Waste Licence Review Application W0167-02

Response to Article 13 Compliance

December 2009

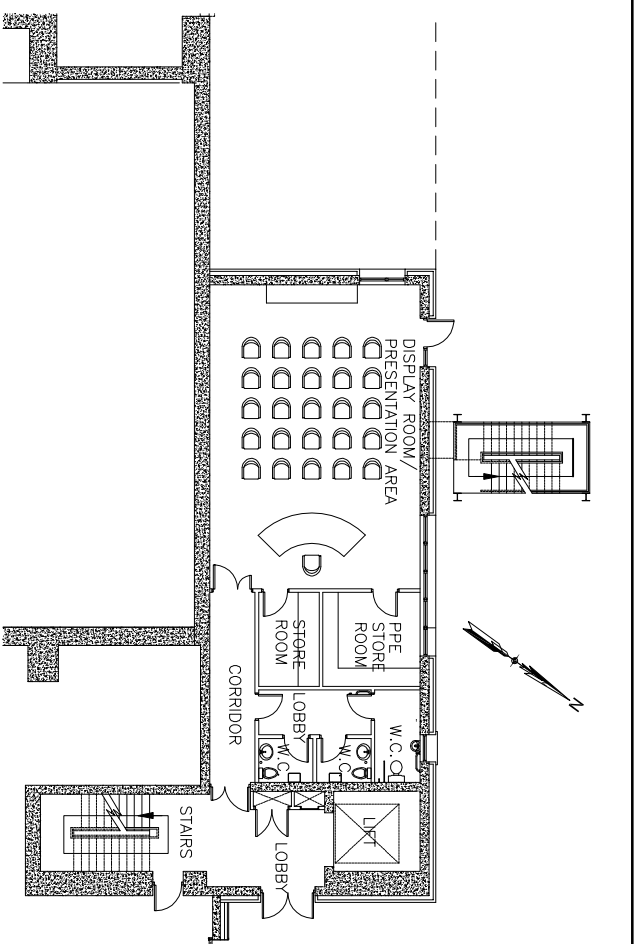
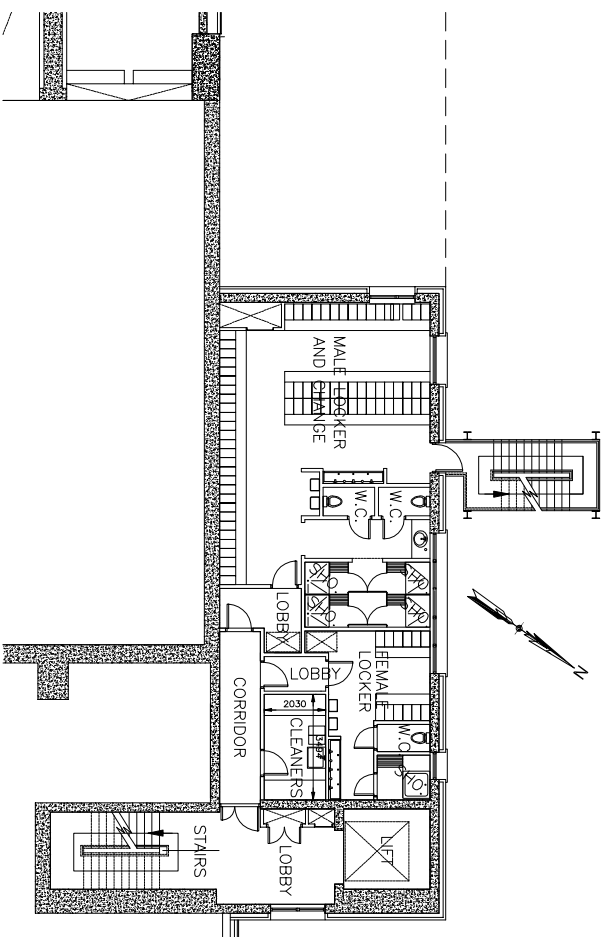
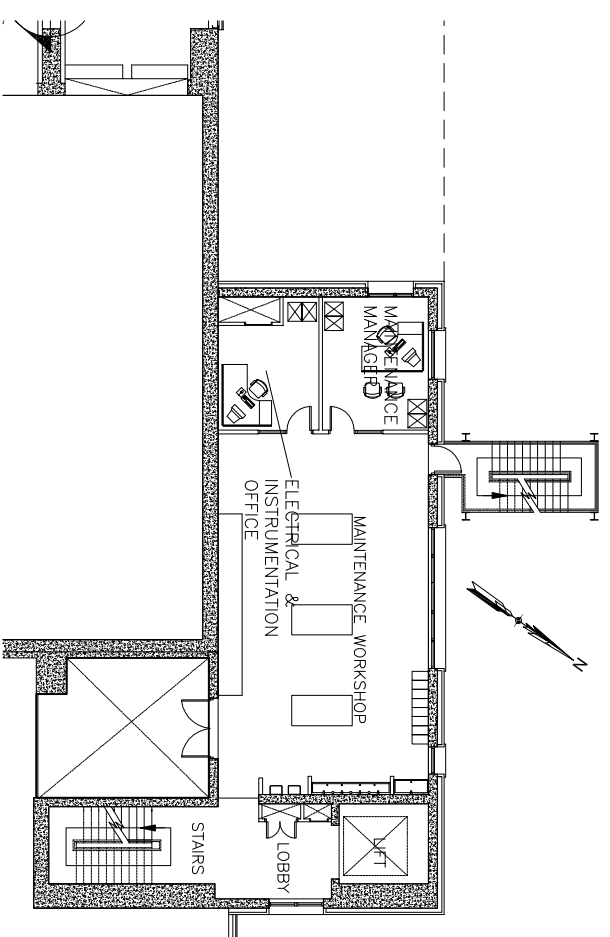
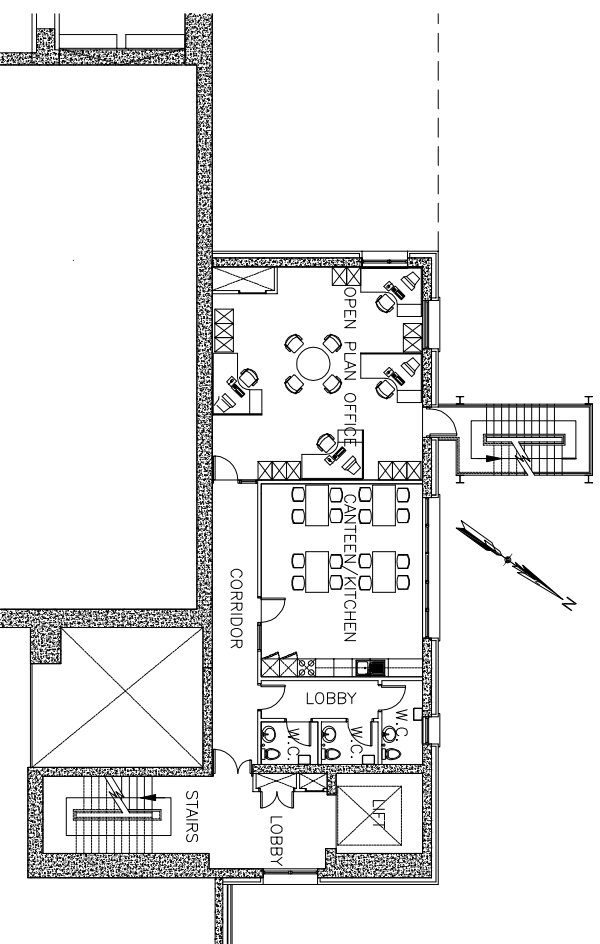
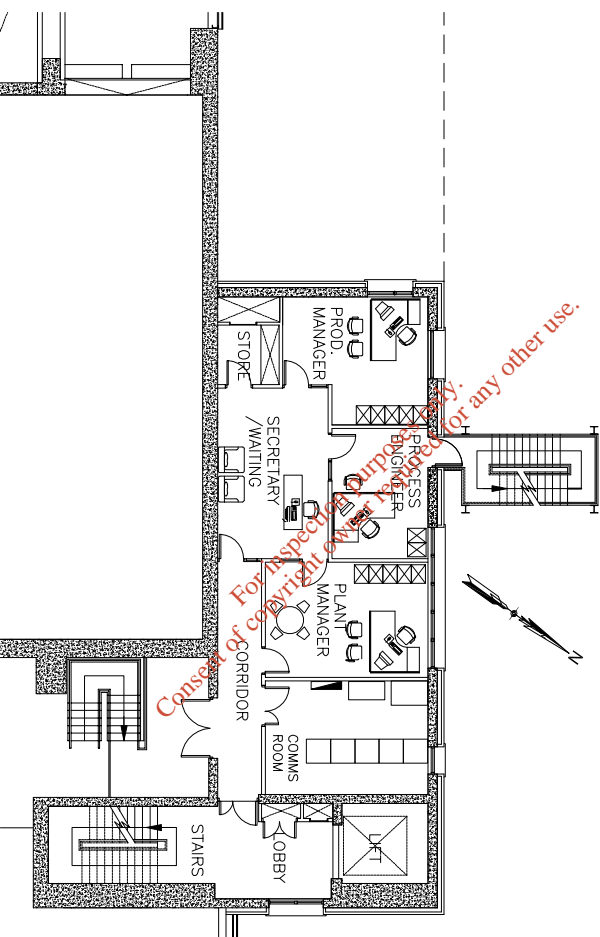
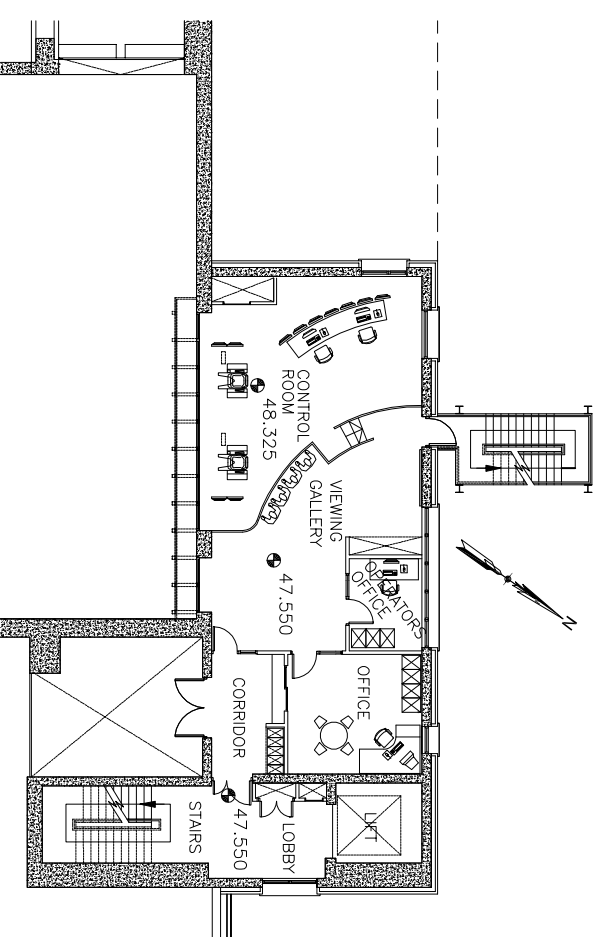
<u>Attachment D.1.m:</u> The workshop and education centre will no longer be in a standalone building but will be integrated into the main process building (see Drawing 18081\WL\012). With the revised layout, the service yard will now provide access to the pump house and water tank, ash handling building, quarantine area, liquid waste discharge area, transformer compound and ESB substation, air condenser units, effluent treatment system for the main process building and storage tanks.
	<u>Attachment D.1.n:</u> Modifications to the layout of site accommodation in the main process building are shown in Drawing 18081\WL\012.
	<u>Attachment D.1.t:</u> The layout of the main process building has been modified. This is described in more detail in Section 1.1 of the 2009 EIS. The building will still comprise four main sections but these will be modified in size and shape. The turbine will no longer be in a separate building but will be incorporated in the main process building. The air condensers, previously on the turbine building, will be relocated to the north of the plant and will cover approximately 45m x 12m in floor plan. This is shown in Drawing 18081\WL\008. Finally, due to the availability of detailed design information, the quantity of boiler ash has been revised back to 3,000 tpa from 1,000 tpa noted in the RWLA.

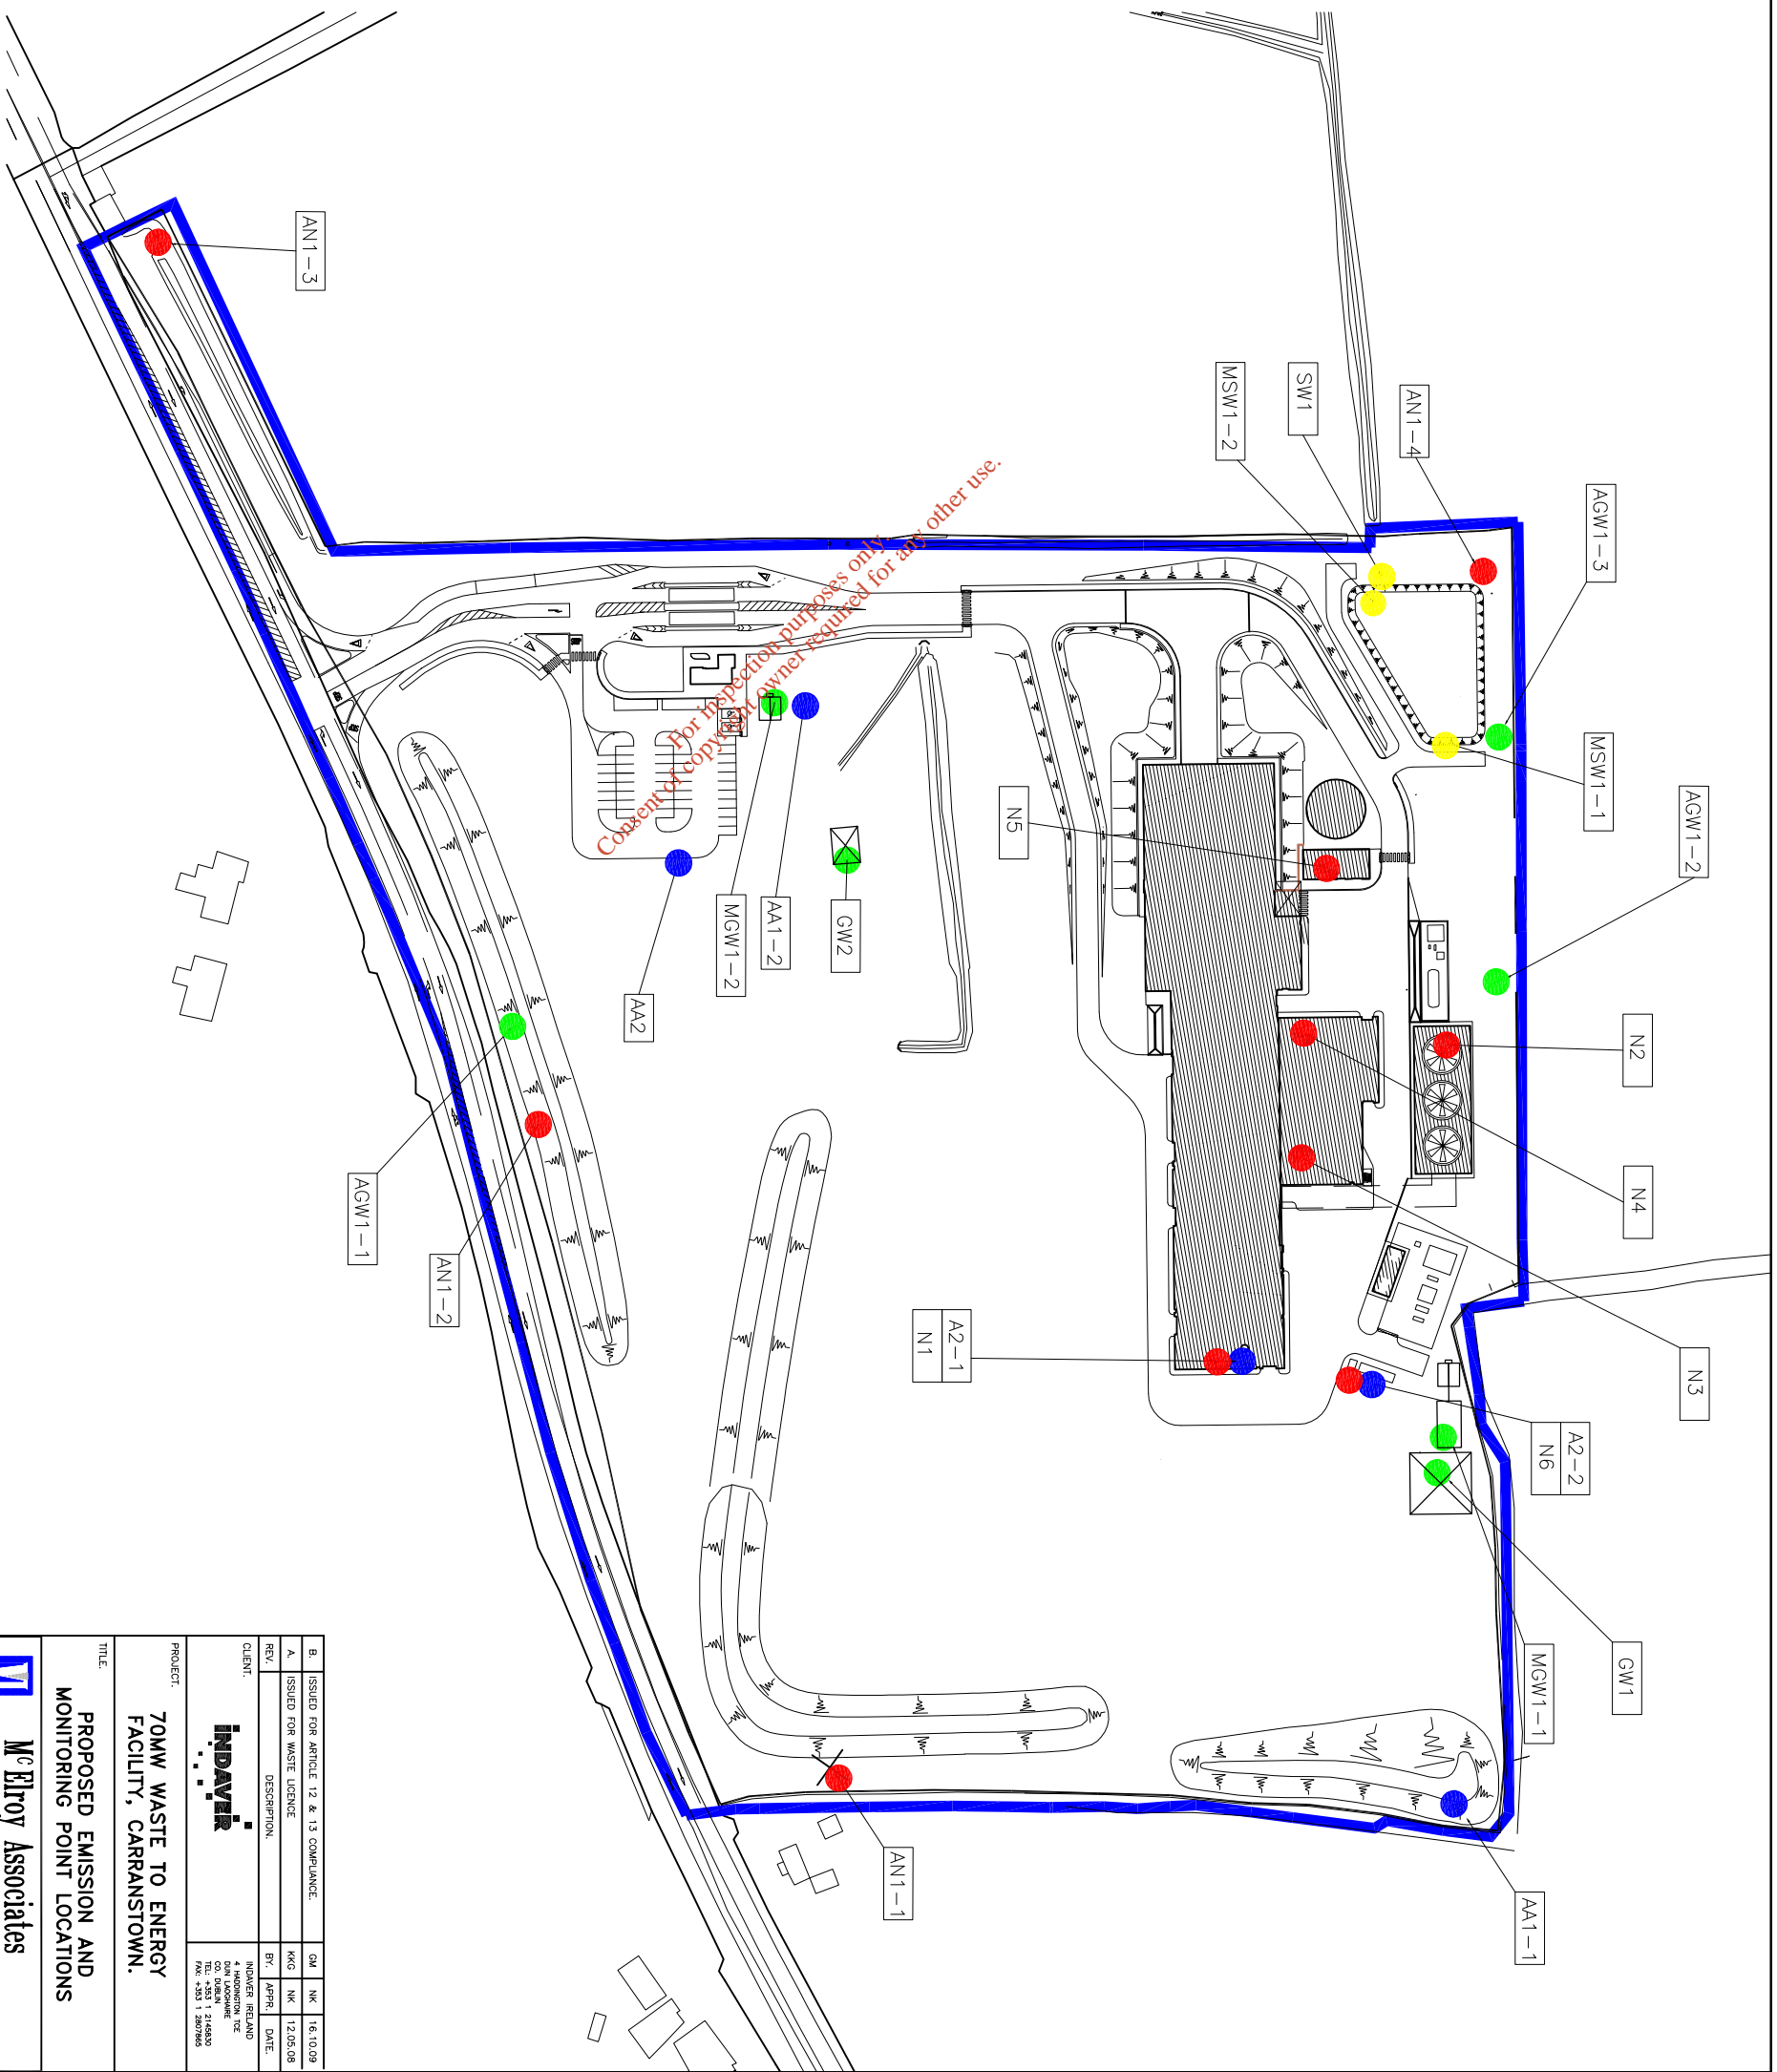
Appendix D11: Plant Layout from Side	The plant layout has been revised with changes to the shape of the main process building and removal of the turbine building. The revised drawing 15013\WL\009 is shown as Drawing 18081\WL\009 in Appendix 13.b
Appendix E1: Location of Emission Points	Some of the emission and monitoring points have been relocated as described in Table 13.b. The revised drawing 15013\WL\013 is shown as Drawing 18081\WL\013 in Appendix 13.b.

Emission Point Ref. N ^o :	A2-1
Source of Emission:	Waste to energy plant (stack)
Location :	Main process building - See drawing 18081W/L013 in Appendix 13.b.
Grid Ref. (12 digit, 6E,6N):	306331E, 270963N
Vent Details Diameter:	2.2m
Height above Ground(m):	65m
Date of commencement:	Hot commissioning ³ of the facility will commence in the second quarter of 2011.

Emission Point/Area Ref. N ^o :	GW2
Emission Pathway: (borehole, well, percolation area, soakaway, landspreading, etc.)	Percolation area
Location :	Adjacent to security building – see Drawing 18081\WL\013 in Appendix 13.b.
Grid Ref. (10 digit, 5E,5N):	30617E, 27089N
Elevation of discharge: (relative to Ordnance Datum)	32.6m O.D
Aquifer classification for receiving groundwater body:	Rkd (regionally important , diffuse karst aquifer, good development potential)
Groundwater vulnerability assessment (including vulnerability rating):	M (moderate)
Identity and proximity of groundwater sources at risk (wells, springs, etc):	Table 10.2 of the 2009 EIS identifies wells within a 3km radius of the site. This shows there are 2 domestic wells 600m to the west of the site, 5 domestic wells 1 to 1.5km to the south-east and 1 domestic well to the north. Other wells are further than 2.5km from the site.
Identity and proximity of surface water bodies at risk:	River Nanny (tributary), 180m from site River Boyne 3.5km from site

Table B.2.c: Comparison of Site Layout

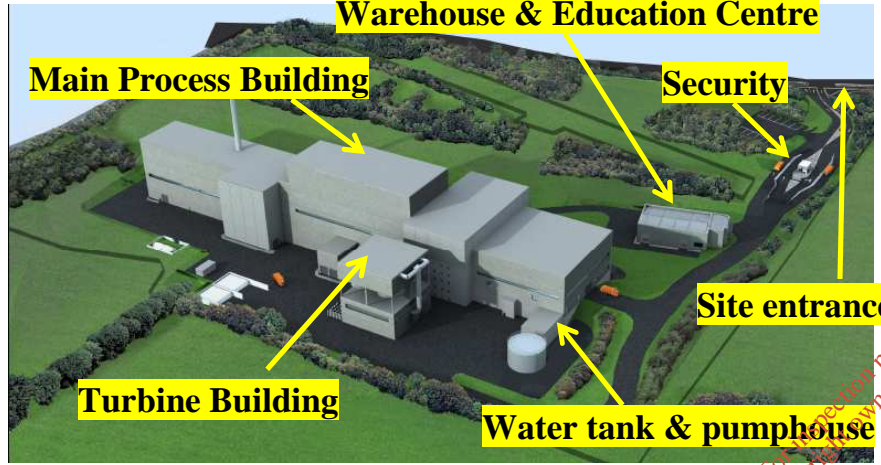
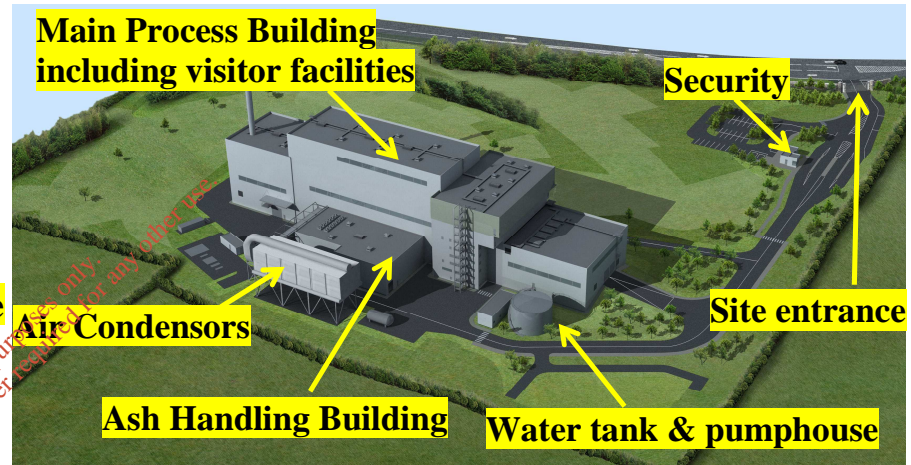
Appendix D1: Site Layout	The site layout has been revised with changes to the main process building shape, addition of an ash handling building, removal of the turbine building and warehouse, redesign of the gatehouse, parking and stormwater attenuation and relocation of the air condensers, storage tanks, pumphouse and quarantine area. These modifications are summarised in Section 1.1 of the 2009 EIS. Drawing 151013\WL\005 has been revised to Drawing 18081\WL\005 in Appendix 13.b
Appendix D2: Site Entrance Drawing	The Site Entrance drawing 15013\WL\007 has been modified to show minor changes in the gate, which now comprises a single rolling panel, and to the design of the wall. Refer to Drawing 18081\WL\007.
Appendix D3: Plant Layout	The plant layout has been revised with changes to the process building shape and removal of the turbine building. Drawing 15013\WL\008 has been revised to Drawing 18081\WL\008 in Appendix 13.b.

Revised Figure 2.D.b: Waste Acceptance and Handling Process Flow

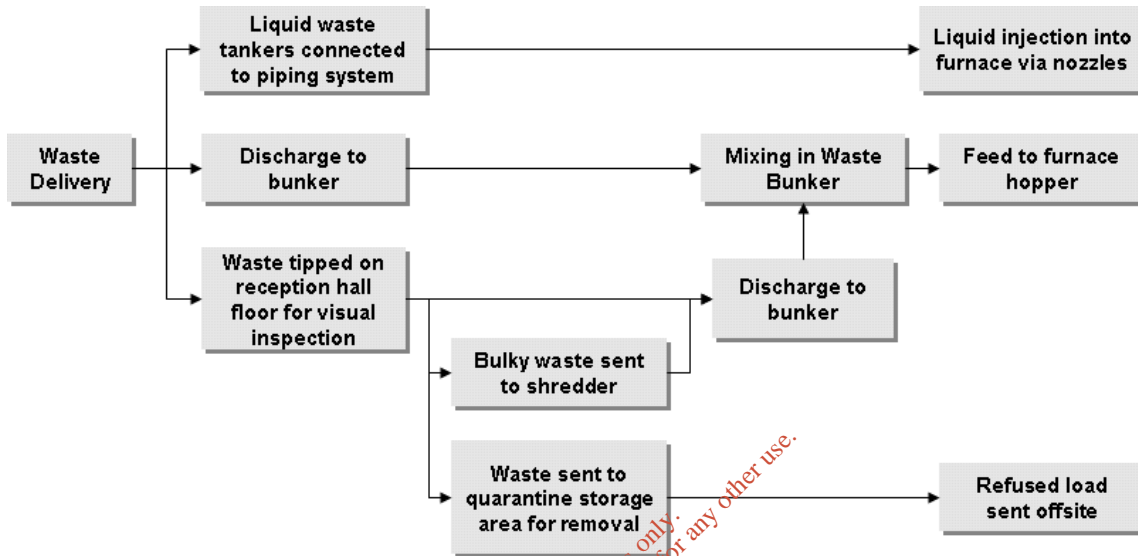
In addition to the waste acceptance and handling operations described in the RWLA, a direct injection system will be installed to facilitate the acceptance of liquid wastes.
